Madison's Central Business Improvement District (BID)

MEMO

Re: Potential pedestrian and bicycle projects

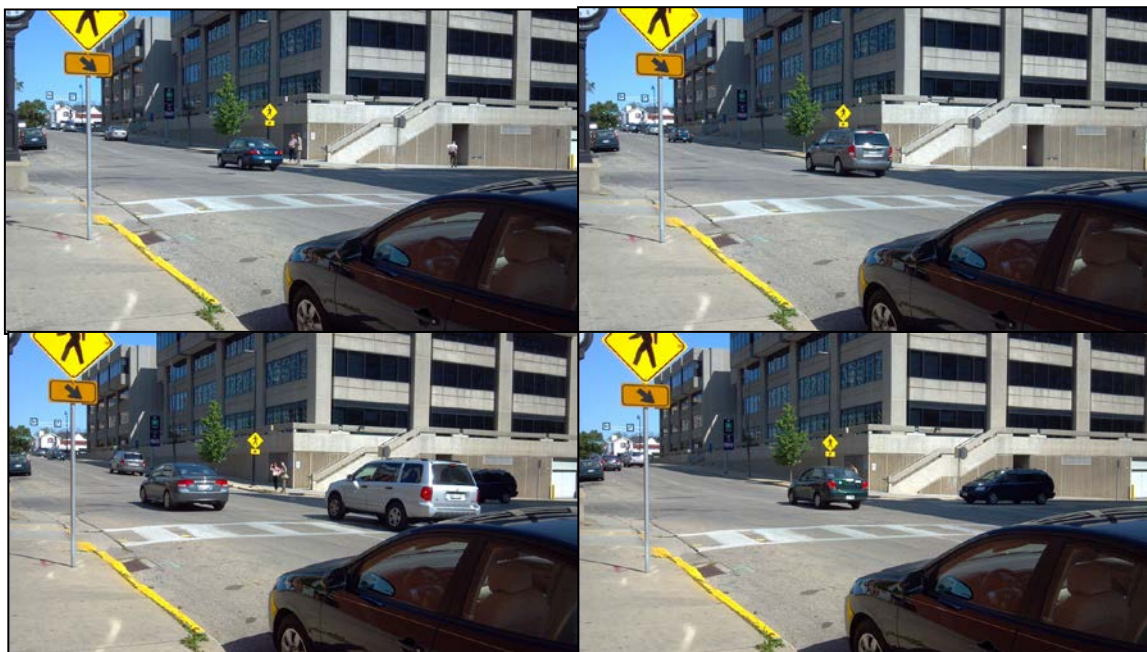
2) **The Johnson, State, Henry intersection** is a very difficult one with the three streets meeting and the conversion of bike, ped, car, truck traffic. A few examples of difficult interactions are below.

- Bikes going up State St. towards the Square stop at Johnson, very often spread out across all lanes of State St. Cars turning on to Henry or trucks turning to State meet the bikes head-on.
- Bikes heading up State often go through the red light at Johnson, turning left to go outbound on Johnson. If a car on Johnson with the green light happens to turn left onto Henry or State, or pedestrians are trying to cross the street, a collision is possible.

Are there better ways to manage, signalize, mark that intersection? Is there a better way to indicate where bikes should wait (on right half of street?) There is a bike box on State St. on the east side of the State/Johnson intersection, but not the west side, described above.

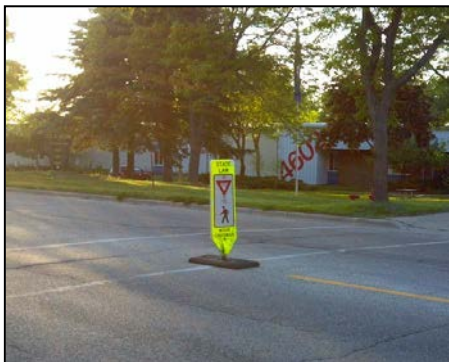
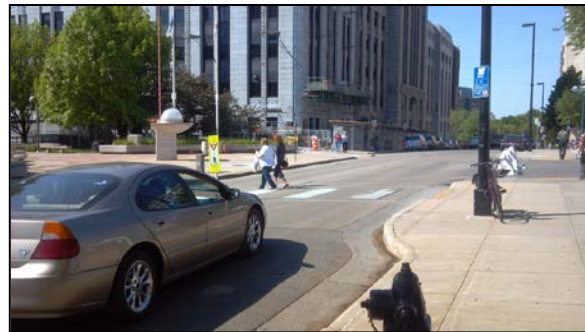
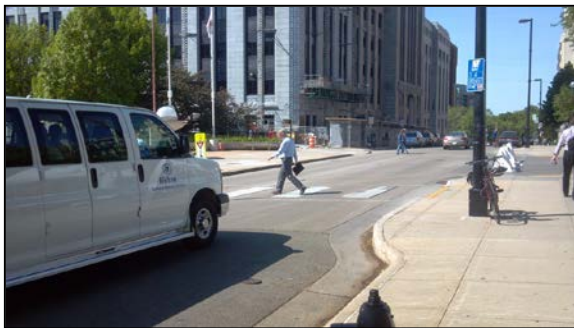
Crosswalk pavement markings are inconsistent and lead to confusion (e.g., if the rules are the same for all crosswalks, why are they marked differently?). E. Main & Webster has different styles within same intersection, where Dayton & Carroll (next page) has a third style. It's my understanding that cost is one reason that all Outer Loop crosswalks are not "striped" to make them more prominent to motorists and cyclists. Can paying for this be part a capital project?

Crosswalk signage at Outer Loop intersections is inconsistent, and some types seem to work better than others. Has a study been done to see which signage and markings work best?

E. Main & Webster has yellow diamond-shaped signs plus the marking above, and seems to be an intersection where motorists and cyclists yield the least, as in the following attempt of a pair of pedestrians to cross:

N. Carroll and E. Dayton, near MATC Downtown Education Center and city's State St. Capitol Parking Garage, has an overhead sign, which seems to get lost against the skywalk, and be difficult for motorists and cyclists to see.

Is this the best sign for this intersection?
